The Egyptian Civil Aviation Authority requests and authorizes you to place the Response of EgyptAir to October 31, 2000 Submission of The Boeing Company regarding the EgyptAir Flight 990 investigation into the public docket for the EgyptAir Flight 990 investigation.

Response of EgyptAir  
to  
October 31, 2000 Submission of  
The Boeing Company  
Regarding  
The EgyptAir Flight 990 Investigation

Figure 4. Elevator Deflection from Ground Test A and Analytical Model  
Single PCA Control Valve Jam on the Right Elevator, 770 psi Feel Pressure, Pilot  
Control Sweep

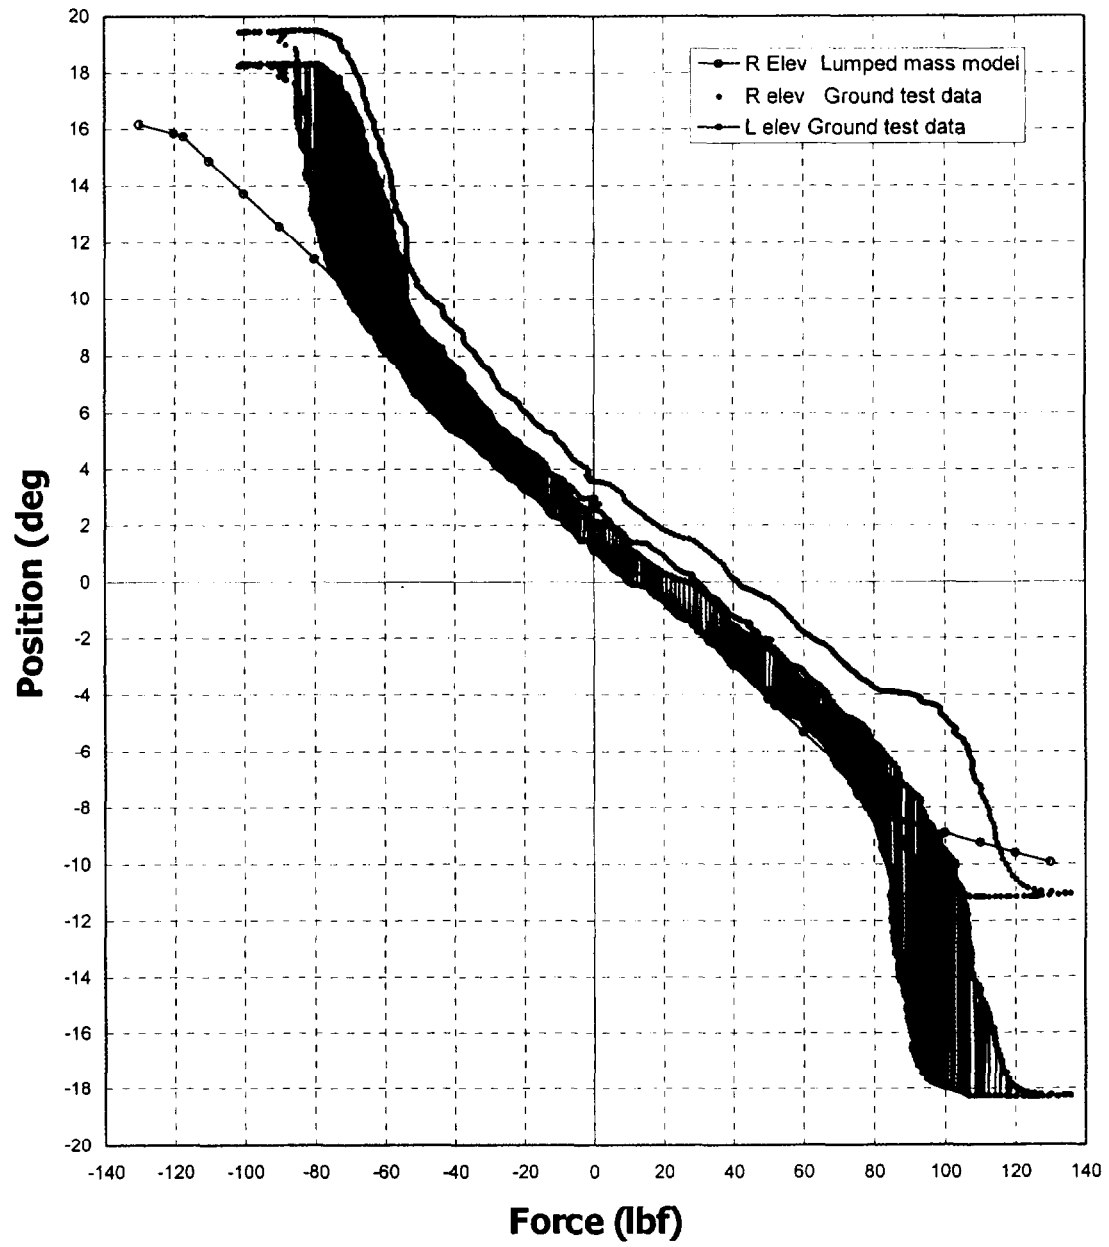
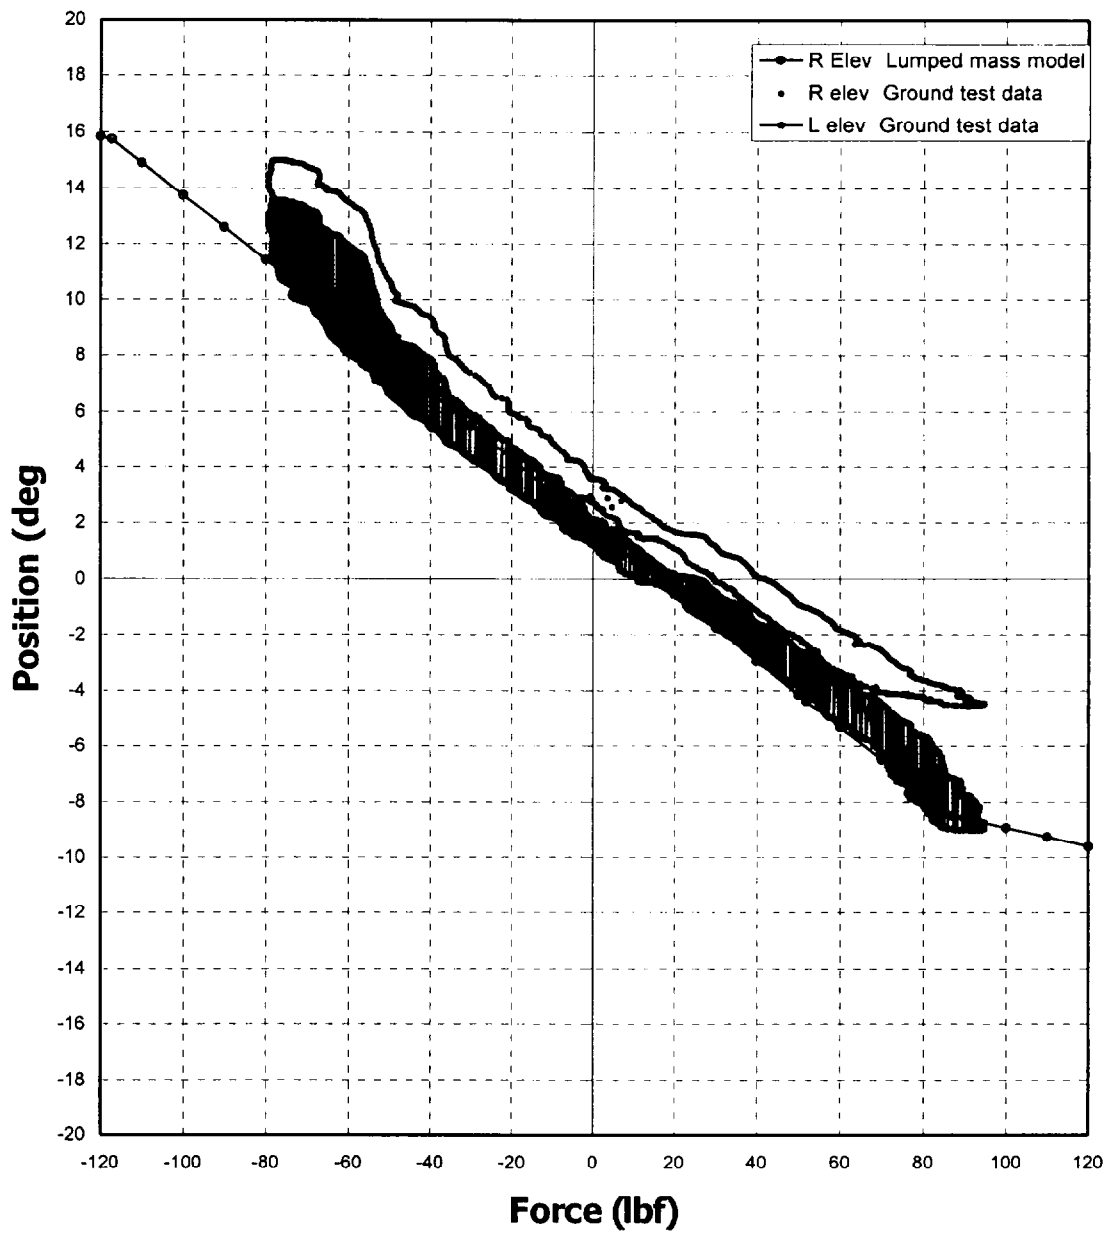
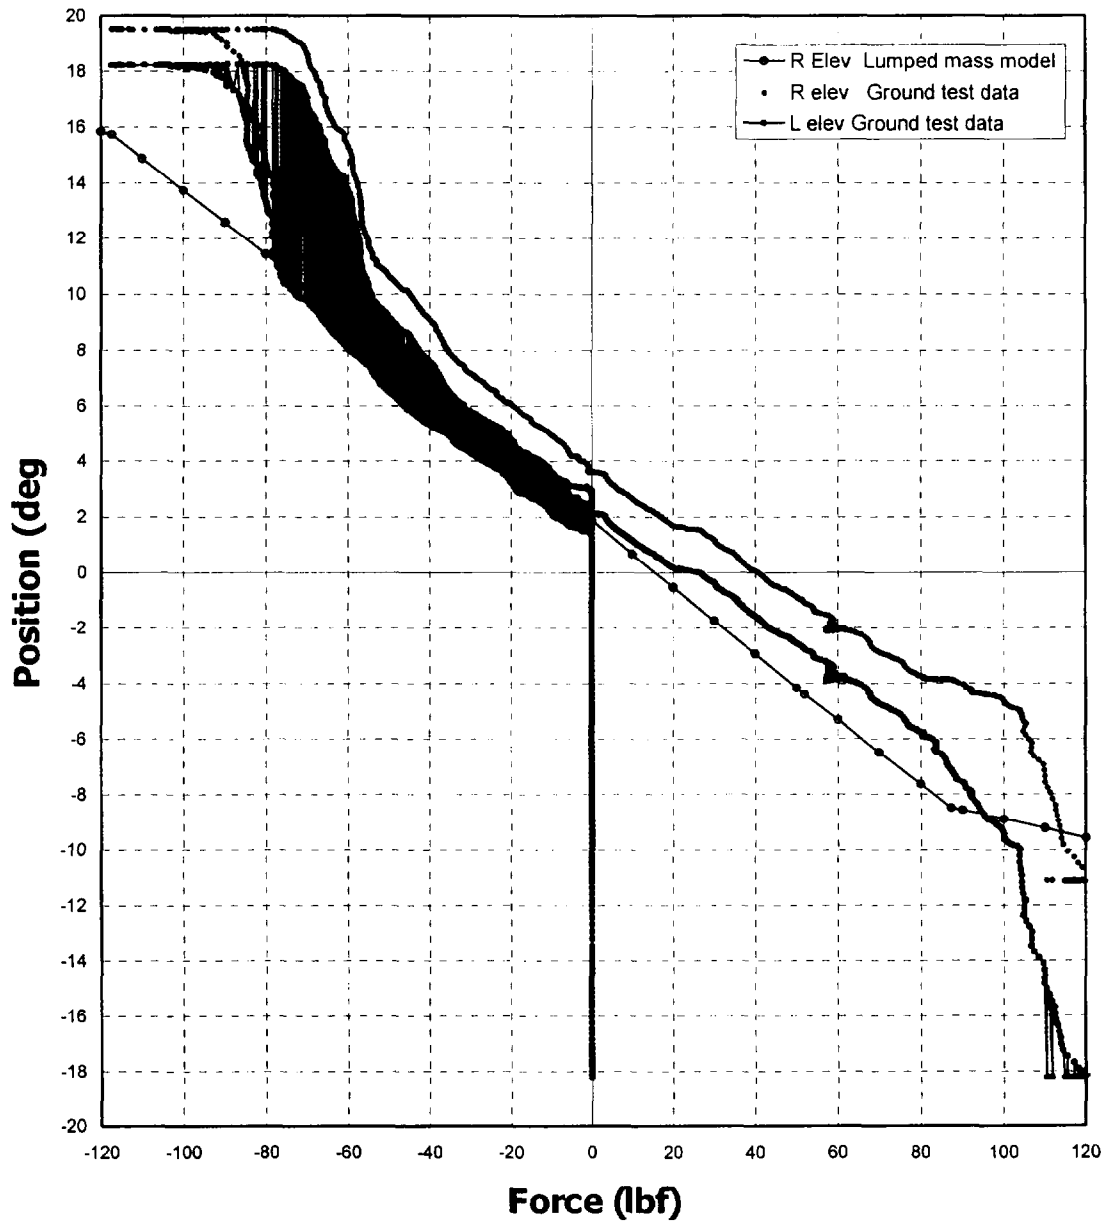
Figures 4, 5, and 6, which are extracted from the ground test data, indicate the elevator movement at a no-load condition as a result of a single PCA valve jam in the TED direction.<sup>2</sup> These figures show the results of three separate tests under the same test conditions –single PCA jam, 770 psi feel pressure, and pilot column sweep. They indicate that the right elevator is always leading the left elevator and are not consistent with the mathematical model included in Boeing report B-H200-17068-ASI-R2 -Split Elevator Failure Scenario, dated September 29, 2000 and Boeing report B-H200-17026-ASI, -767 Elevator System Operation with Regard to Column Splits, Aft Quadrant Splits, and Column Jams, dated August 2, 2000.

Figure 7. Expected Elevator Deflection as a Result of Dual PCA Valve Jam Failure  
(Produced by the NTSB Performance Group Chairman)

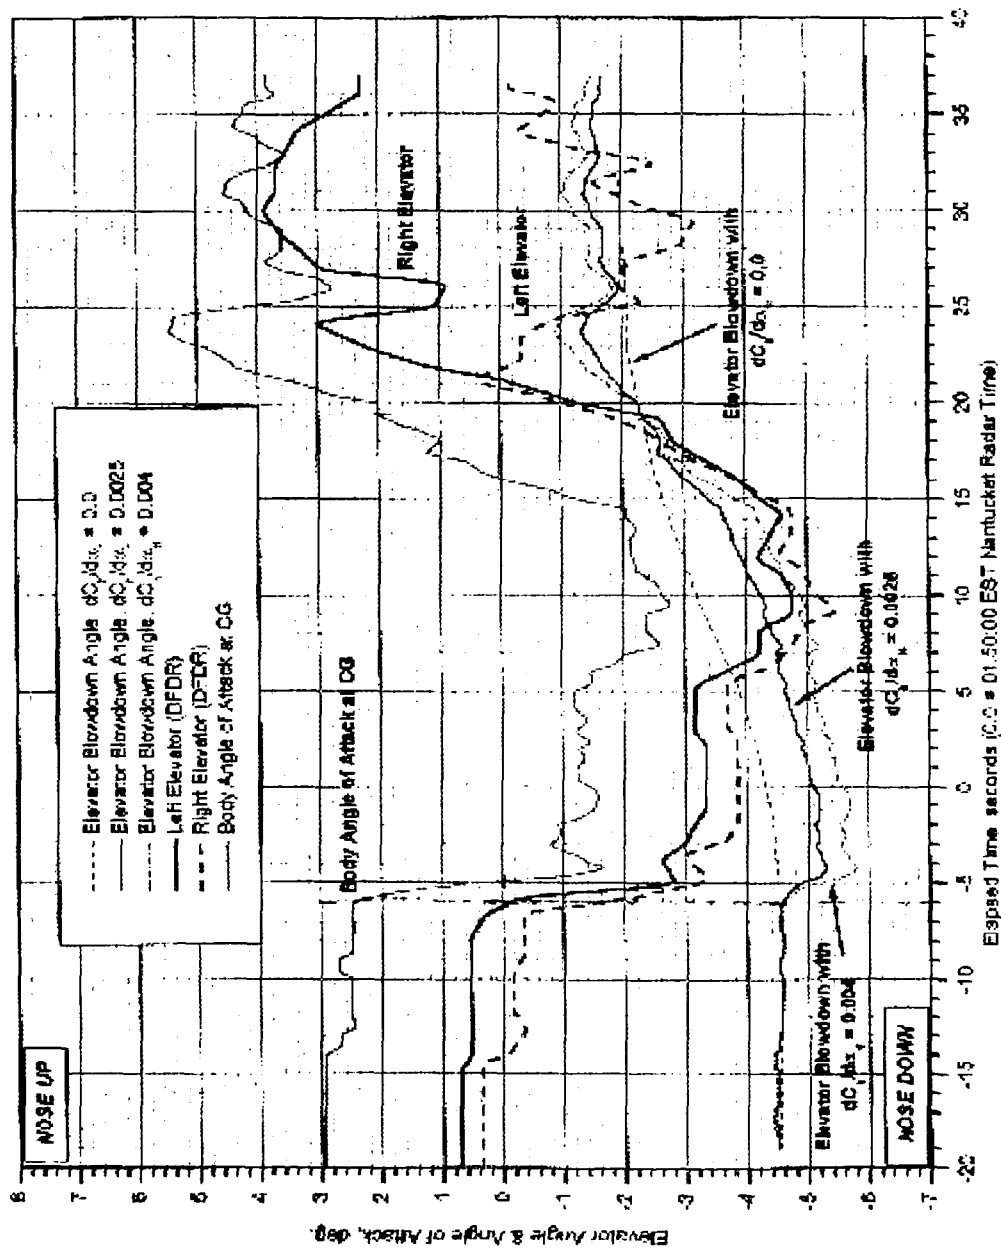
Figure 7 shows the expected elevator deflection as a result of a dual PCA control valve jam using the Boeing hinge moment data with and without considering the effect of airplane body angle variation and the FDR elevator data. These expected deflections were derived by the NTSB performance group chairman and validated by the Egyptian Delegation. From elapsed time of 7 seconds, the calculated right elevator position is within 1 degree of the FDR.<sup>3</sup>

<sup>3</sup> Figure 7 is from the NTSB and does not account for any differences caused by the rate at which the failure occurred. In addition, the labels for right and left elevator are reversed.

Figure 8. FDR Elevator and Aileron Deflection and Derive Mach Number

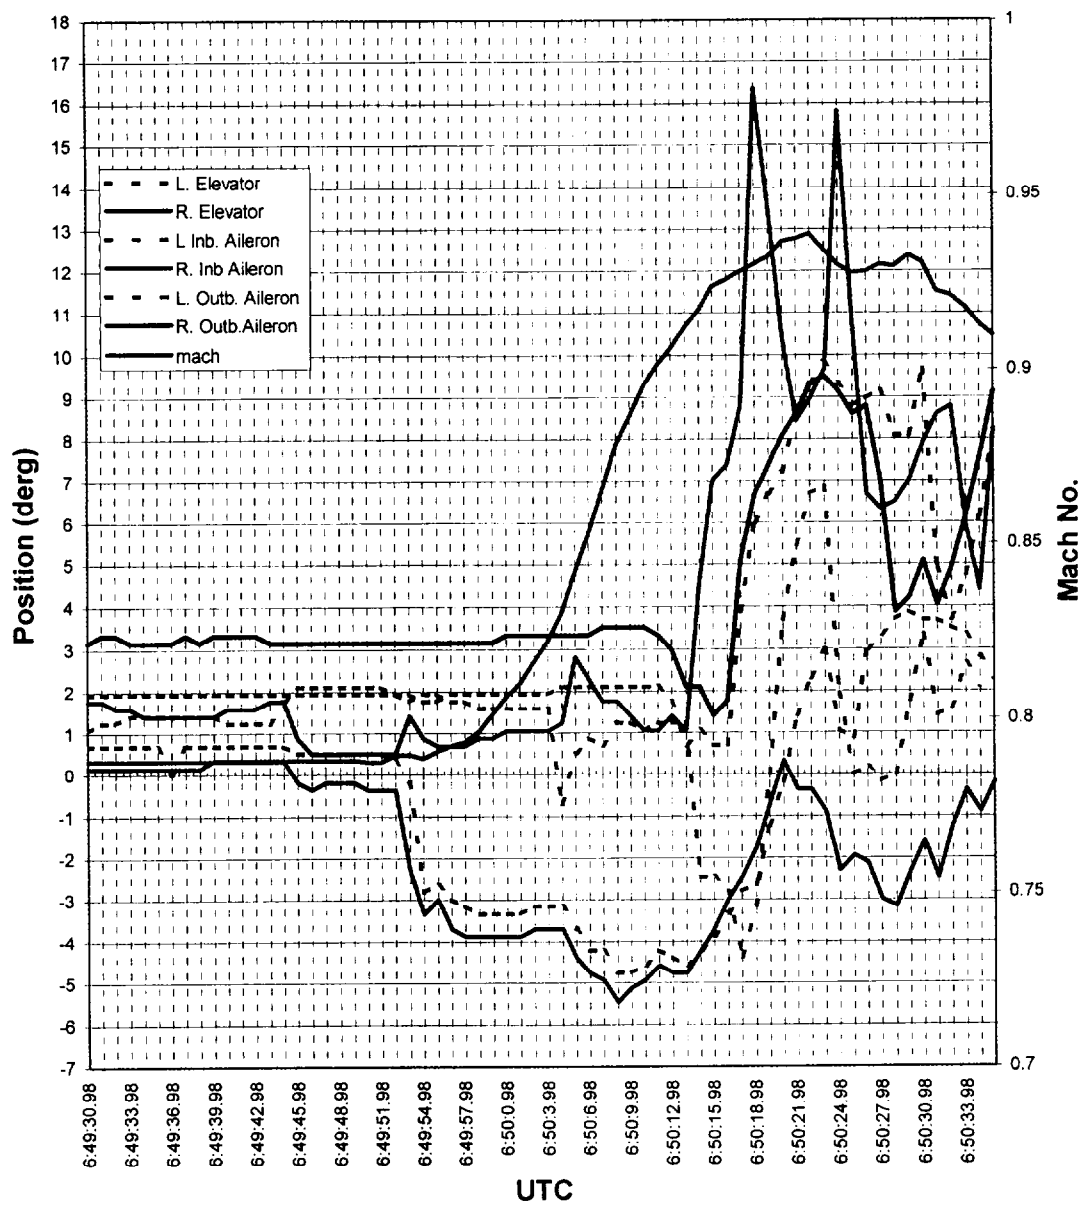
FDR data for aileron deflection is shown in Figure 8. At this time step, the differential aileron deflection was 6.5 degrees, significantly smaller than the above 26 degrees predicted by the split elevator analysis but very close to 4.4 degrees predicted by the streamlined right elevator analysis.

Figure 9. FDR Roll Angle and Derived Body Angle of Attack

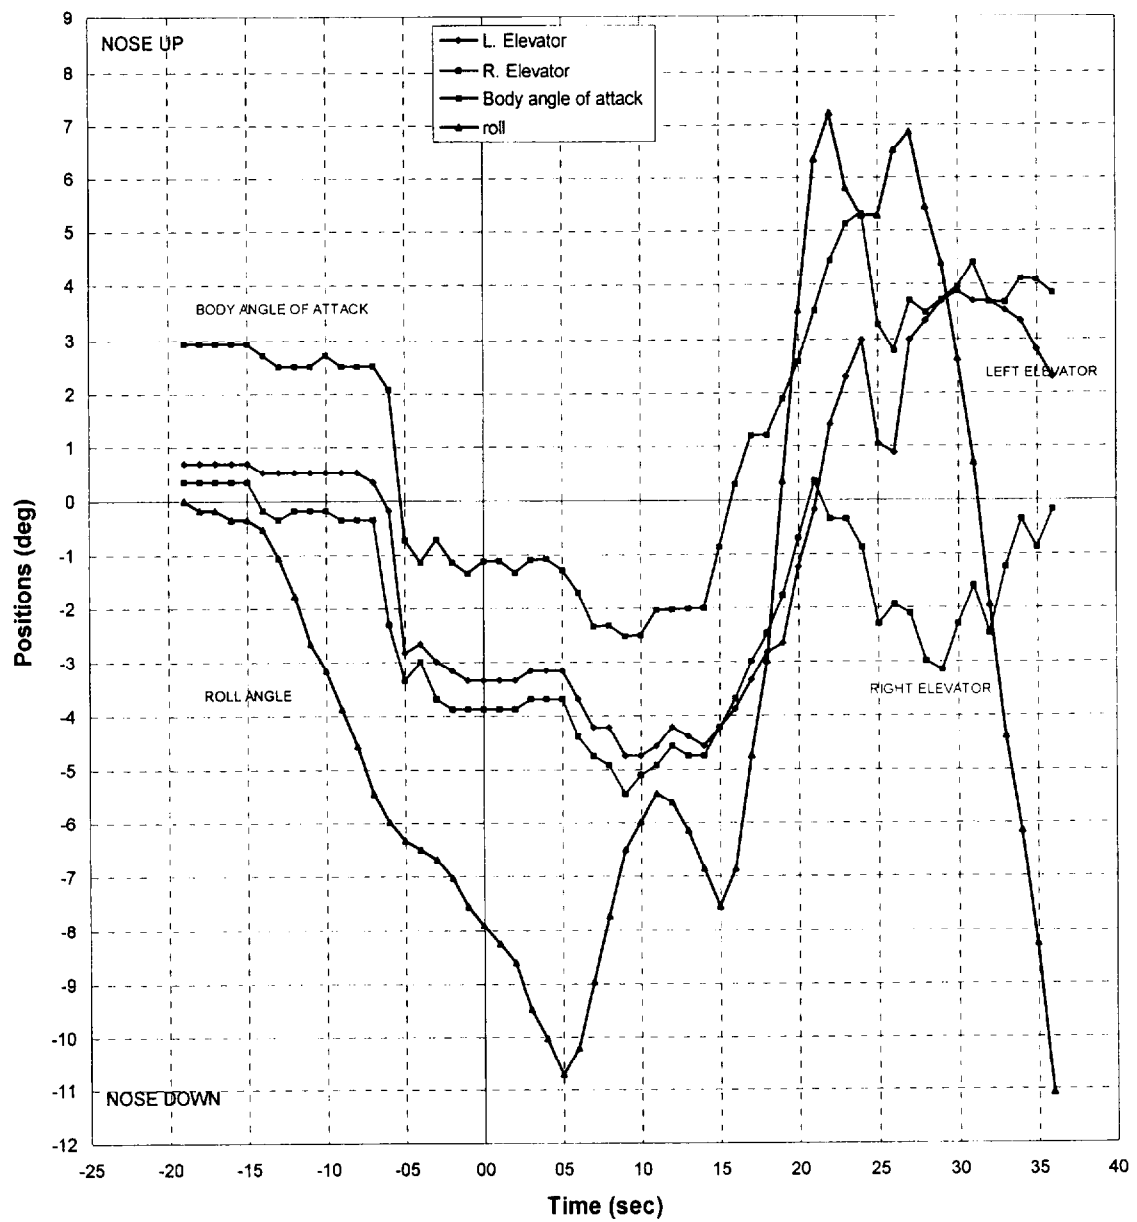
If the elevators have a differential deflection as shown by the FDR data in Figure 9, they will produce unequal lift on the left and right sides of the tailplane resulting in an aircraft rolling moment. The methods of Roskam (Airplane Design, Part VI, Roskam Aviation and Engineering Corporation) were used to estimate the lift on the horizontal tail. Basic lift for the left and right tailplane was calculated using the angle of attack as recorded by the FDR in Figure 9. The elevator was treated as a plain flap and the incremental lift on the left and right surfaces was calculated. These lifting forces were then multiplied by a moment arm assumed to be acting at one-third the elevator half span. This resulted in a net rolling moment due to the differential deflection of the elevators. One time slice 1:50:28 ET( time = 28 seconds on the x-axis), was chosen to make these calculations. The relevant parameters are listed below:

The rolling moment coefficient for the inboard ailerons was then estimated. The outboard ailerons were assumed to be locked out at this high airspeed. Figure 9 demonstrates that the roll angle was small during this time period. The aircraft was well controlled in the roll axis; therefore, the rolling moment due to elevator would be balanced by the rolling moment from the ailerons. Equating the rolling moment due to differential elevator deflection with the restoring rolling moment due to ailerons, a differential aileron deflection was calculated. The result is

Figure 11. Pitchover Simulation, Right Elevator Missing

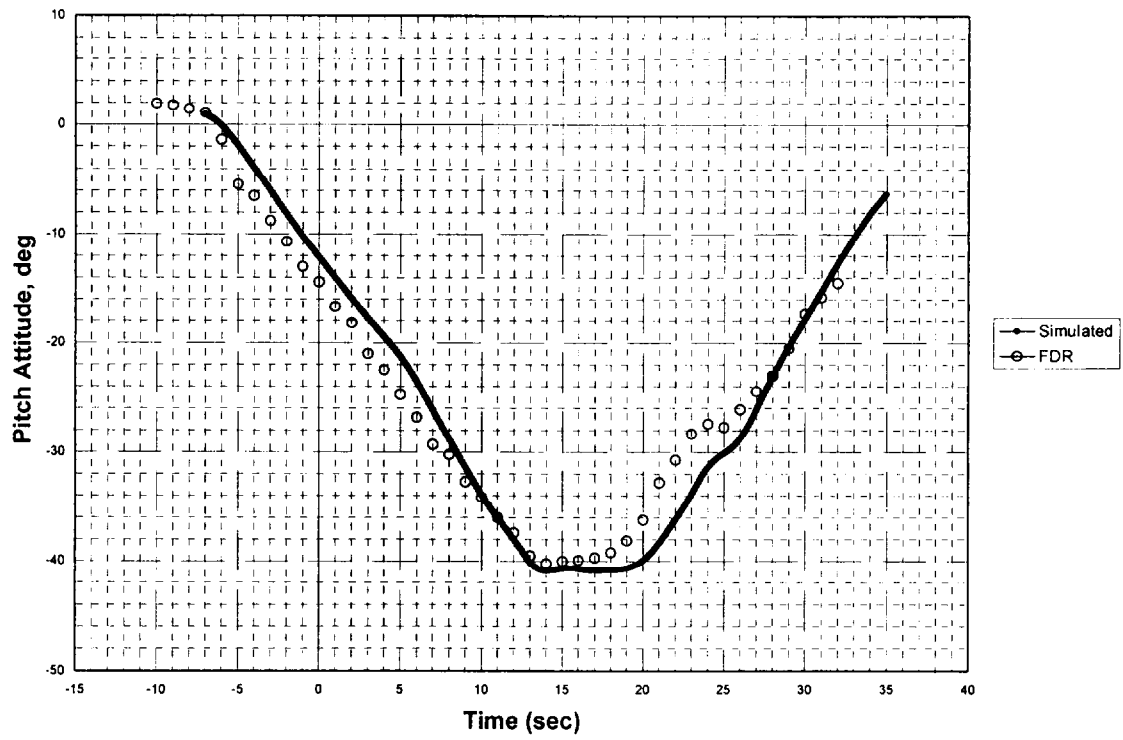
The results in Figure 11 are calculated assuming that the right tailplane was no longer producing a lift increment due to deflection of the right elevator. The maximum nose down pitch angle agrees very well with FDR data, and the simulated pitch begins to recover very closely in time to the FDR pitch attitude.

Figure 15. Aileron Position from B-767 Ground Test Results Extracted from Boeing CD

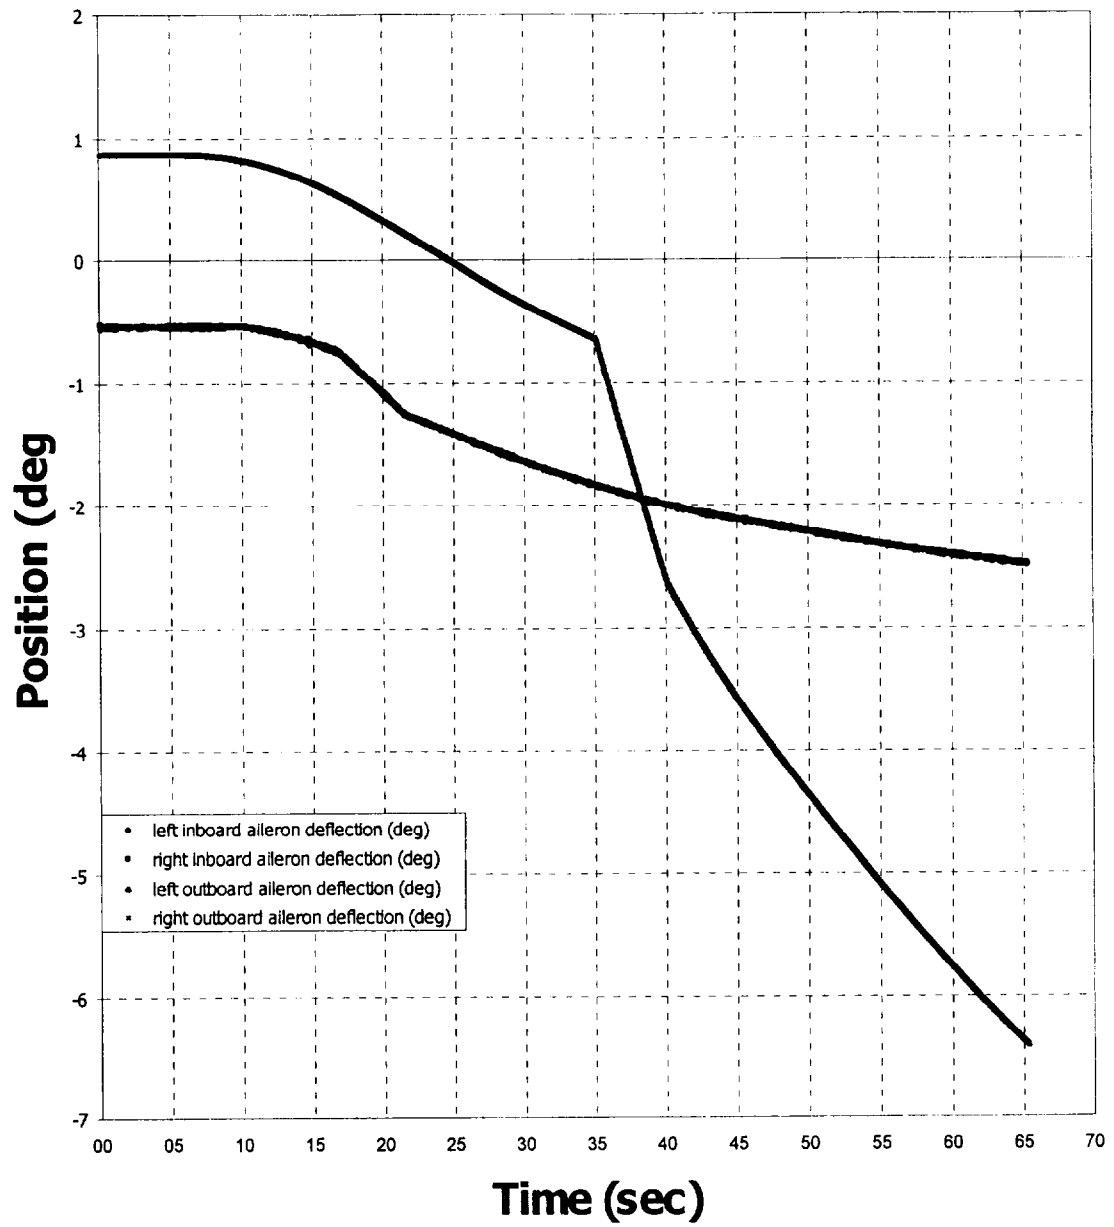
- The E-Cab data produced an unrealistic relationship between control wheel force and wheel movement (see Figure 14) and showed the movement of the outboard ailerons at speeds beyond the lockout speed (see Figure 15).
